**Supplement
to the Montague Wind Power
Facility Application for
Site Certificate**

Prepared for
Oregon Department of Energy

March 2015

Figure K-6a
Land Capability Classification - Detailed View

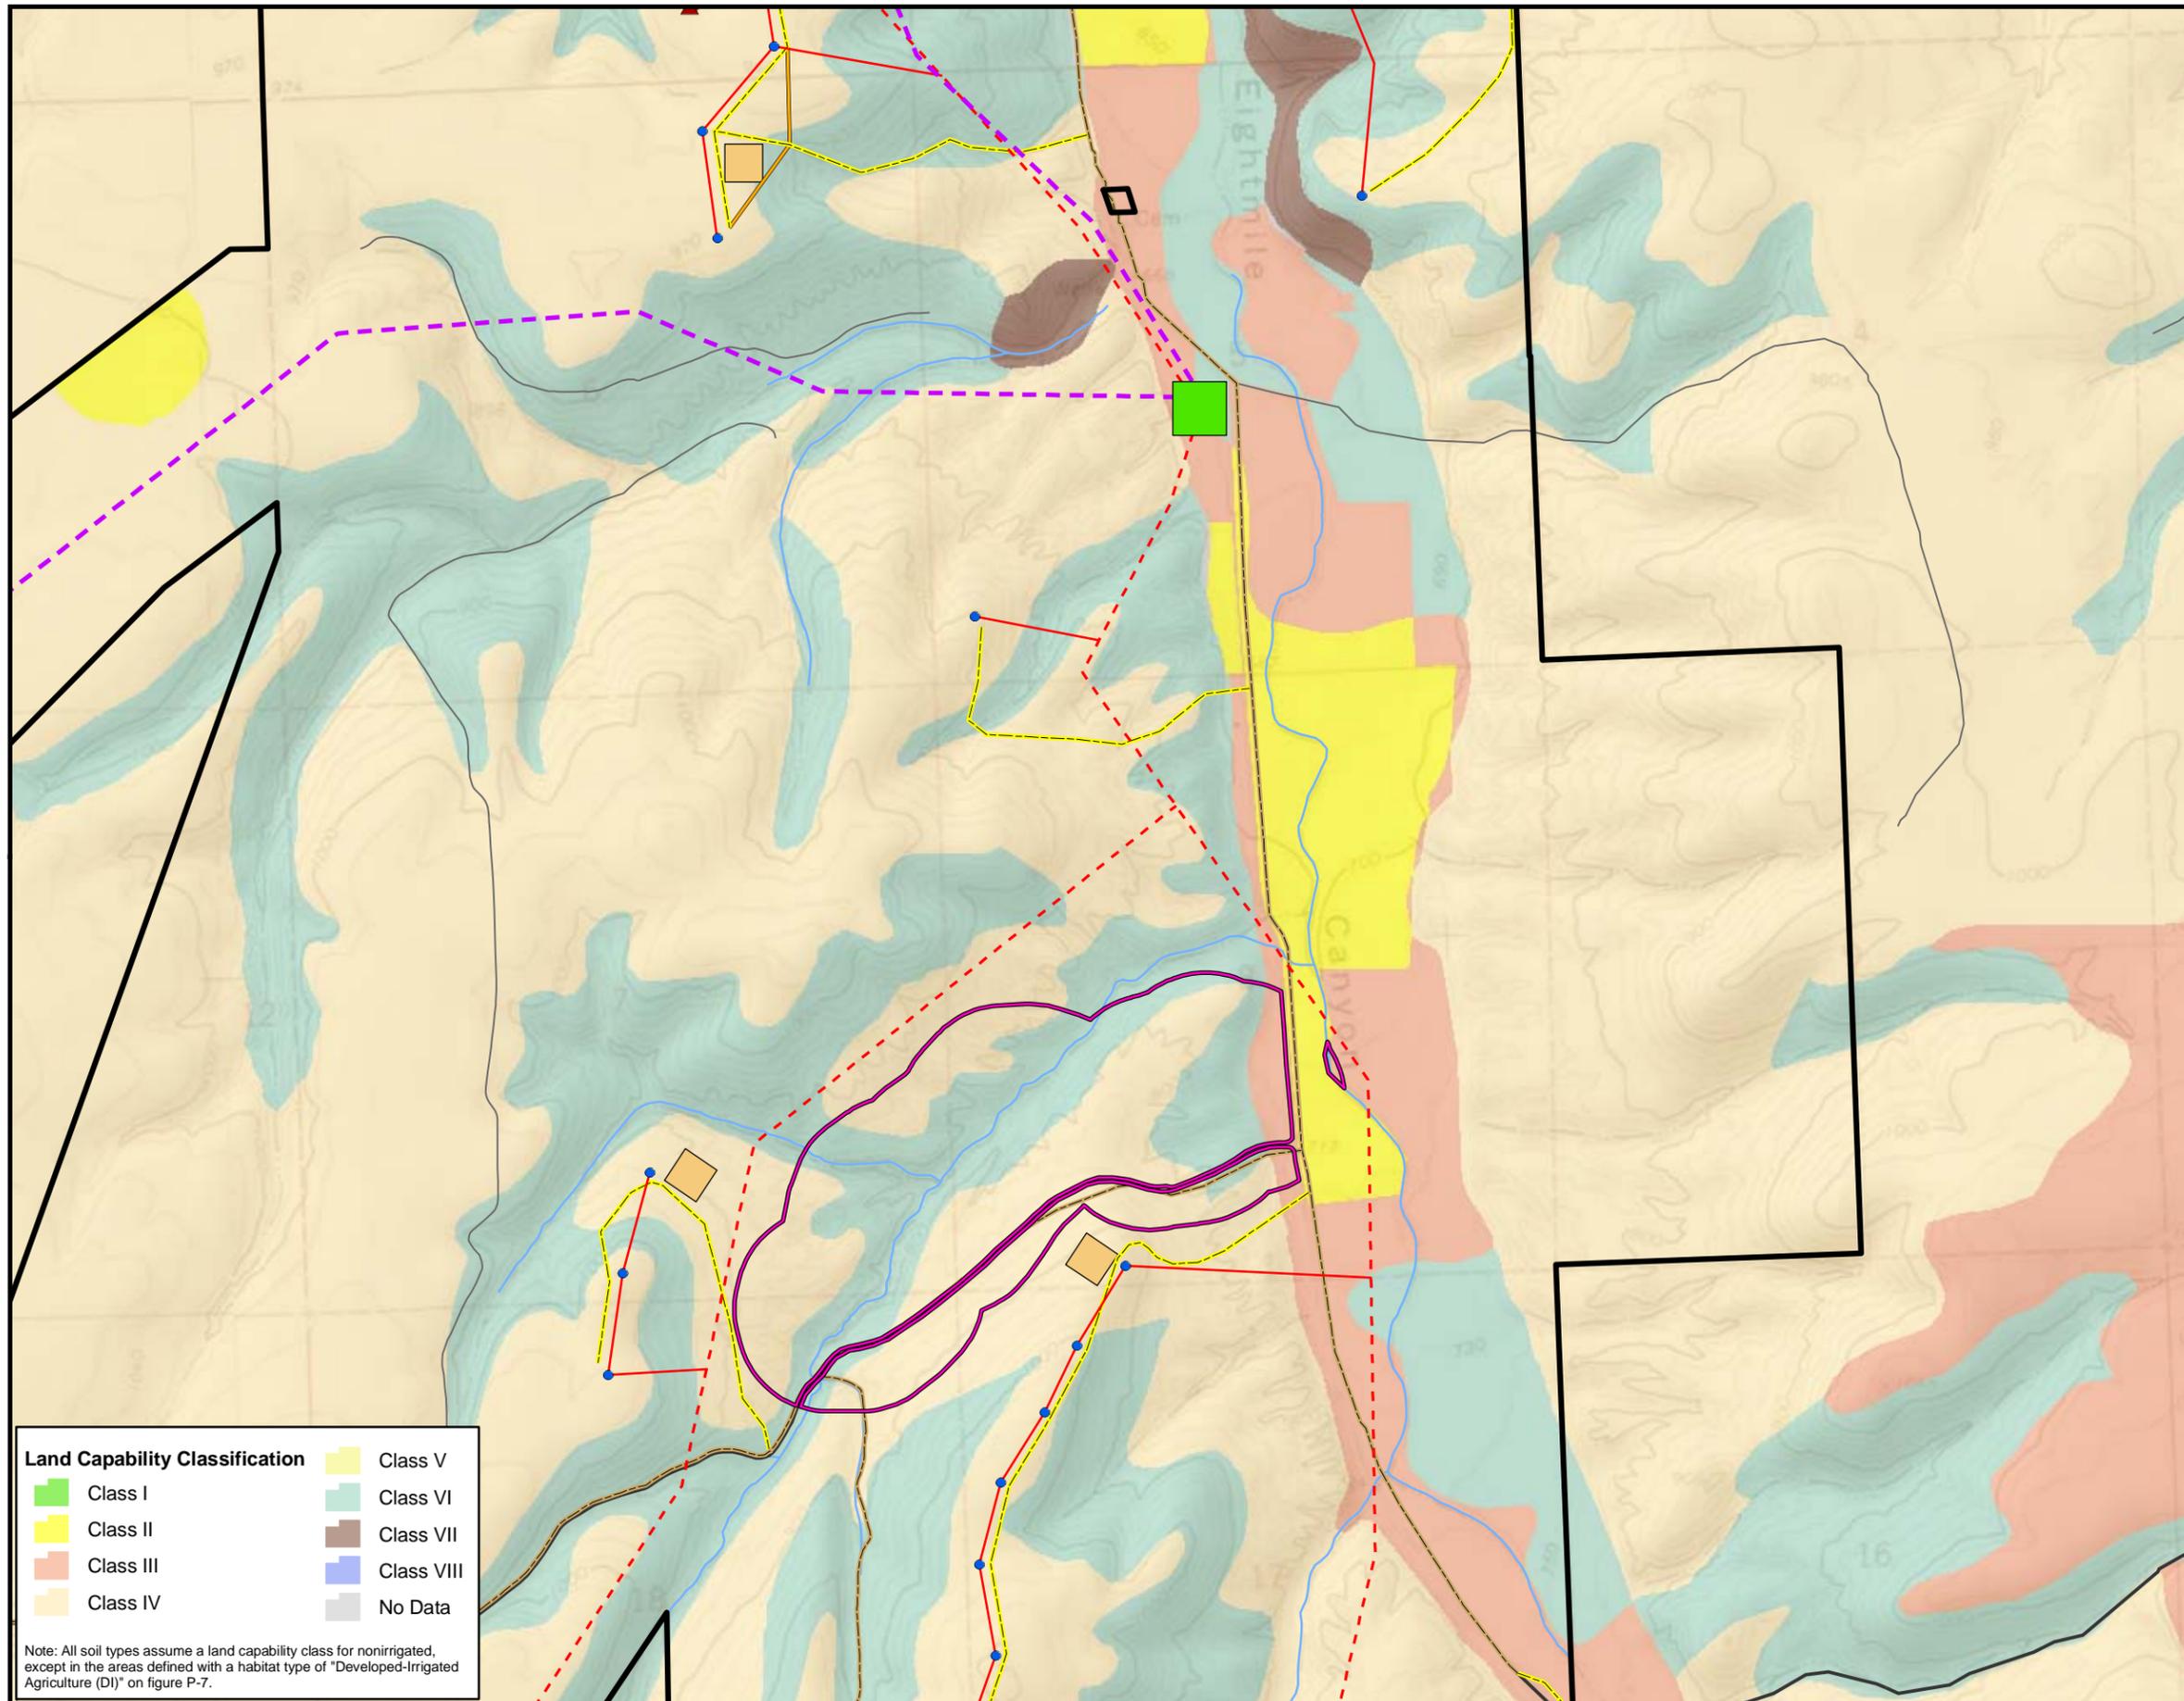
K-34 says that the calculation of "high-value farmland" was based on a "conservative" assumption that various listed soil types are irrigated. If non-irrigated soils are properly classified (as non-high-value), how would that change the data shown in Table K-1? How would it change Figure K-6?

[Note, if you provide a new Figure K-6, please use higher-contrast colors to help us distinguish between soils that are "high value" and soils that are not "high value."]

Based on the revised Figure K-6, it appears that there are only a few small pockets of HV farmland within the proposed MWPF site boundary. These HV farmland areas appear to be limited to a small areas of Class II soil (colored bright yellow), mostly within Eightmile Canyon. There appears to be sufficient adjacent non-HV farmland where proposed facility components could be located within the proposed site boundary.

We propose that IBR microsite the facility components to avoid all HV farmland within the site boundary, and we would recommend that the Siting Council adopt a site certificate condition to that effect. Alternatively, if IBR cannot accept such a condition, then we request a revised justification explaining why the Council should conclude that there are no reasonable alternatives to locating facility components on HV farmland, considering the very limited areas of HV farmland shown in revised Figure K-6.

Figure K-6 has been revised. In this revised figure, soil classes are categorized based on whether the soil is actually irrigated (rather than conservatively assuming that all soils within the site boundary are irrigated). As a result, the amount of high-value farmland soils within the site boundary decreased by approximately 96 acres. Of the acres of high-value farmland soils within the site boundary, only 271 of these acres are irrigated and only a little more than 2 acres will be permanently impacted as shown in Application for Site Certificate (ASC) Table P-10 and Figure P-7. Further, rather than excluding Class VII soils from non-high-value farmland soils, Table K-1 has been revised so that non-high-value farmland soils include Class III-VII soils. Table K-1 values were revised based on the acreage of impacts for the current layout from Figure C-4 rather than on the basis of the acreage of impacts for the worst-case scenario layout from Figure P-9. Accordingly, the acreage of impacts to high-value farmland soils has decreased and the resulting numbers represent the actual impact to high-value farmland soils within the site boundary.

The impacts associated with the access road are from improvements to the existing County road (Eight Mile Canyon Road) within an existing County right of way that runs through high-value farmland soils. See Figure K-6a in Attachment K-1. The majority of the high-value farmland soils are located on the east-side of the road, although there is also a thin swath of high-value farmland soils on the west-side of the road. Avoiding impacts to these areas would mean having to re-route the existing County road outside of the current County road right-of-way. To avoid the majority of the high-value farmland soils, the road would need to be moved further west, but this adjustment would cause the road to run straight through Category 1 WGS habitat (see the identified area on Figure K-6a in Attachment K-1).

length and eliminate one of two stream crossings, it is not feasible to span the line across the Category 1 habitat but given the engineering and site conditions. See Figure K-6a in Attachment K-1. Therefore, even though this portion of the Facility would be located on high-value farmland soils and reasonable alternatives have been considered, the proposed collector line route is allowed given the factors in OAR 660-033-0130(37)(a)(A).

Figure R-1
Scenic & Aesthetic Areas
 1.5-MW Turbine Layout
 (Maximum Turbine Layout)
 Montague Wind Power Facility

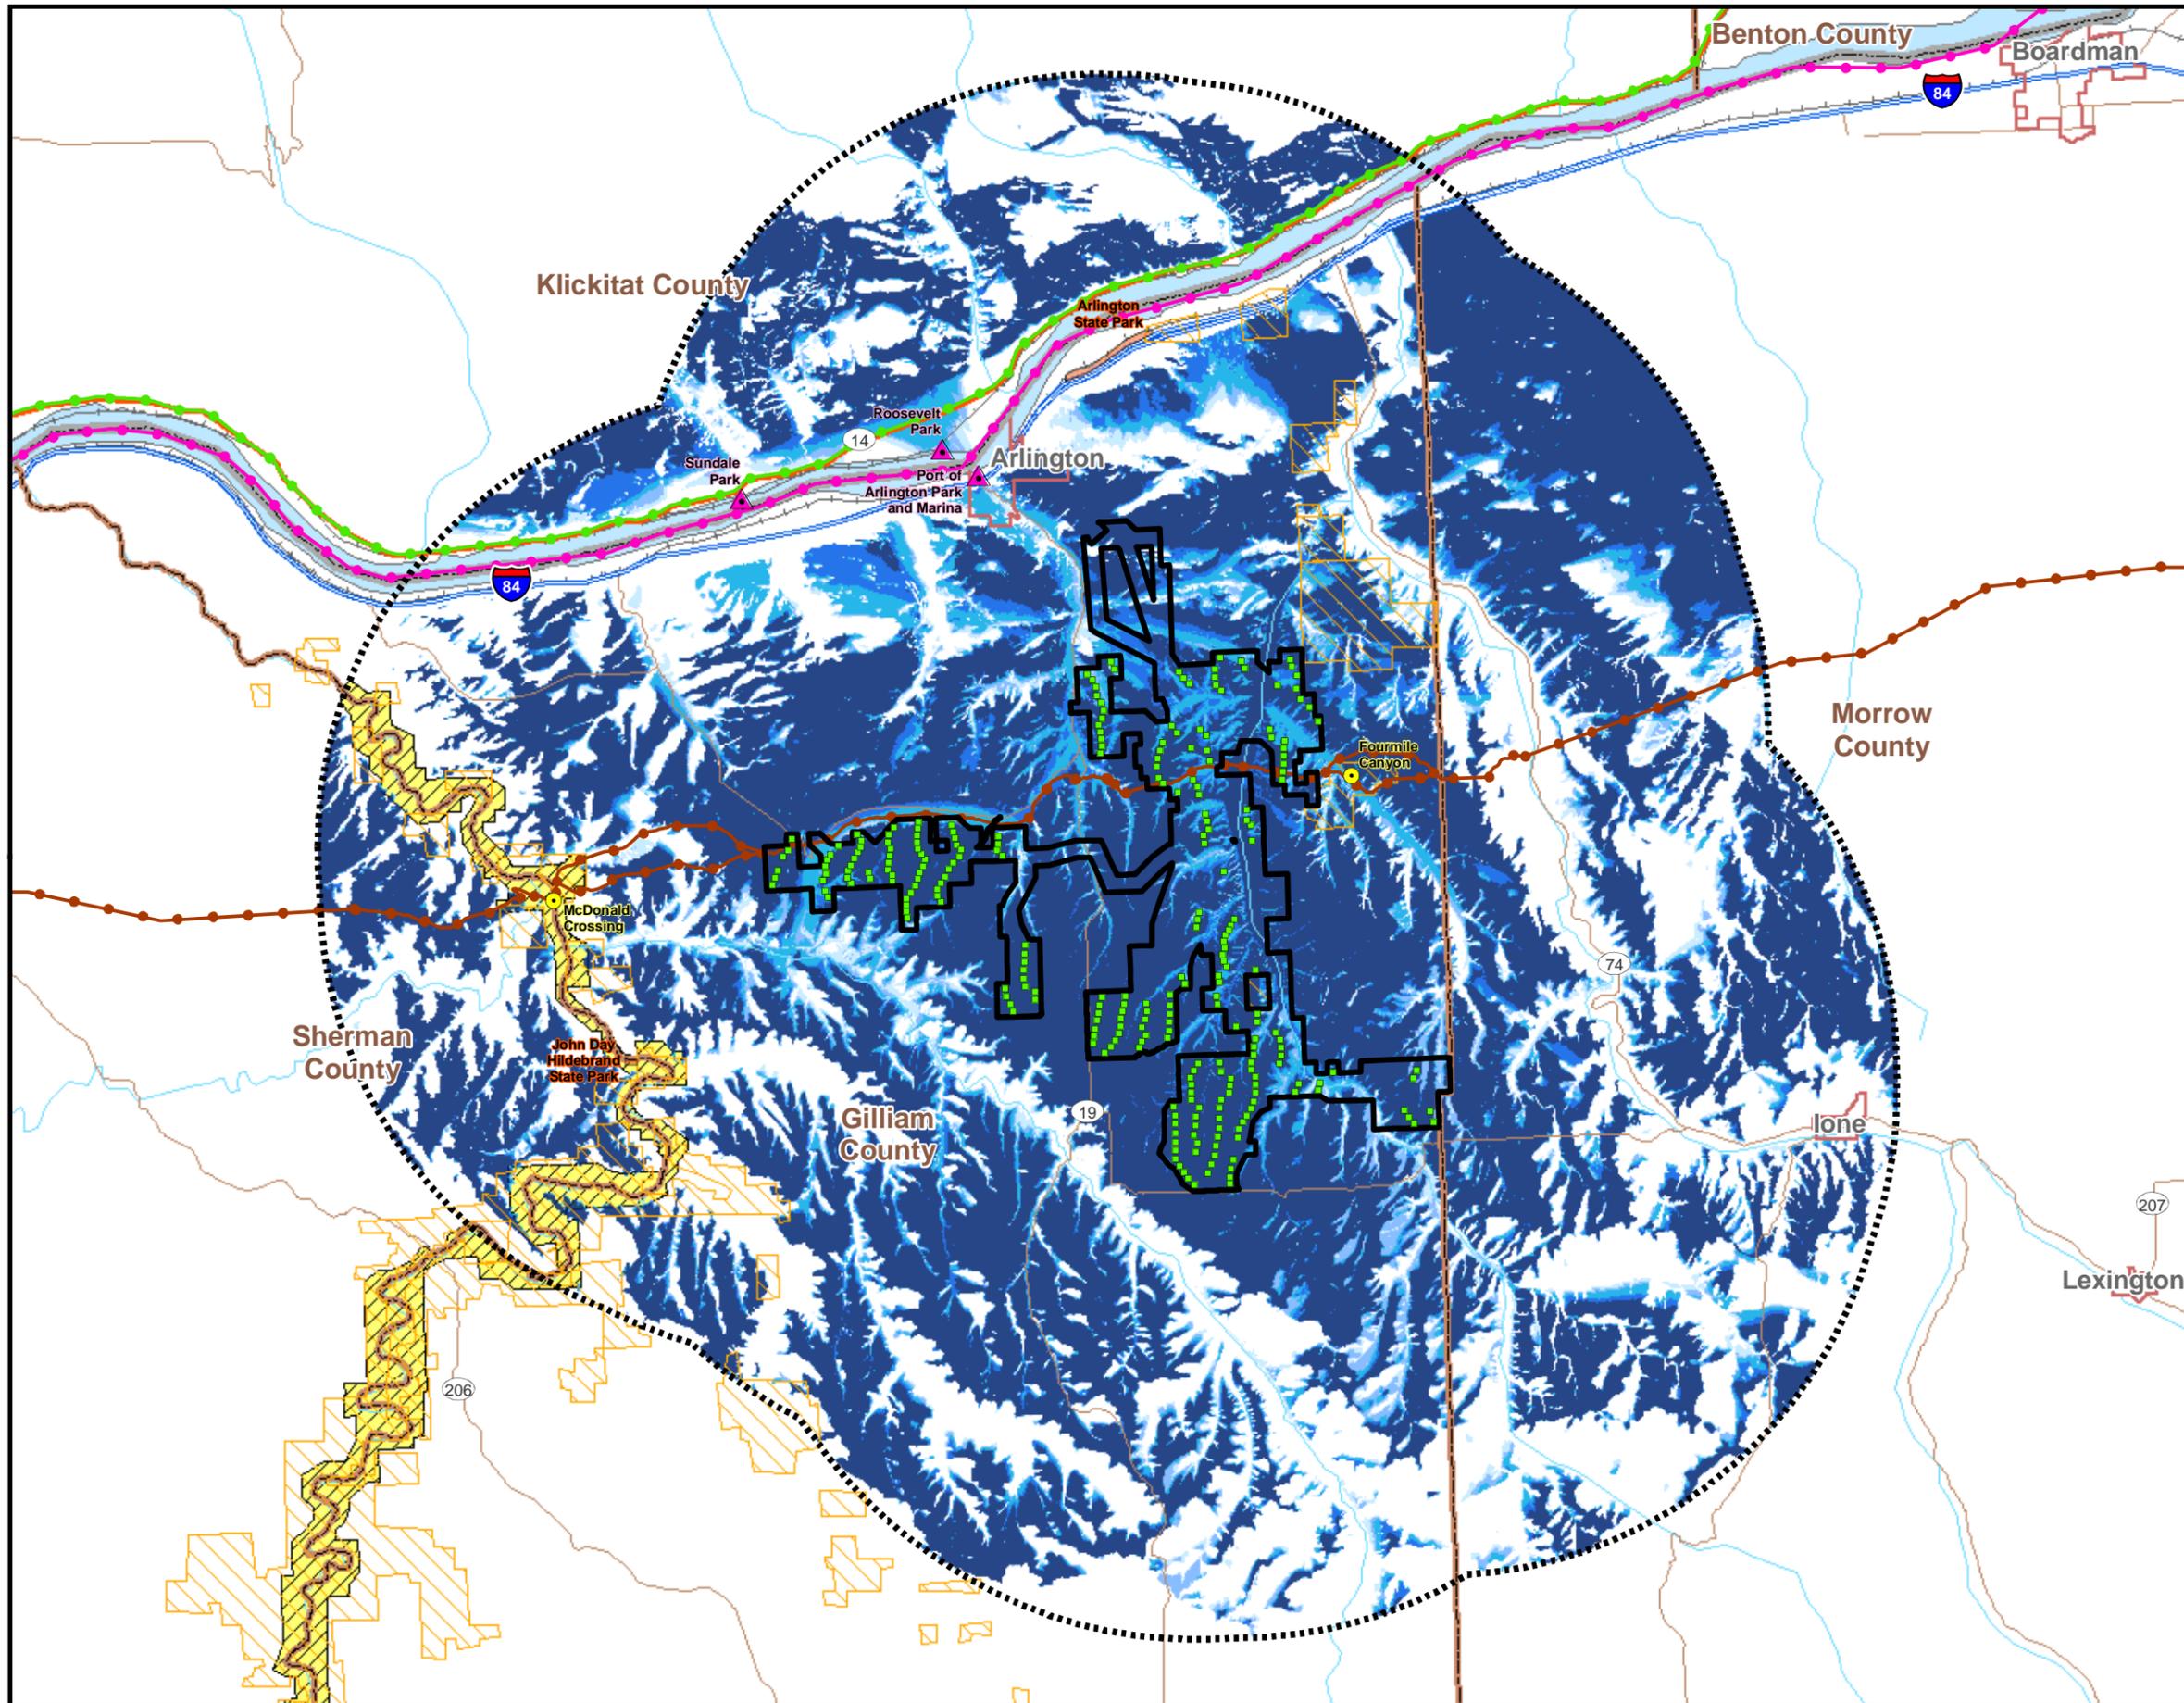
Portions of the John Day State Scenic Waterway lie within the scenic resources analysis area for MWPF, as shown on Figure R-1. We propose to make the same recommended findings for MWPF as were made for Leaning Juniper II with regard to the John Day State Scenic Waterway.

Nonetheless, these two parks were included in a revised ZVI analysis and it was determined that the Facility turbines would not be visible from either park. A revised Figure R-1 is attached to this response table (see Attachment T-1). Thus, even though analysis of these
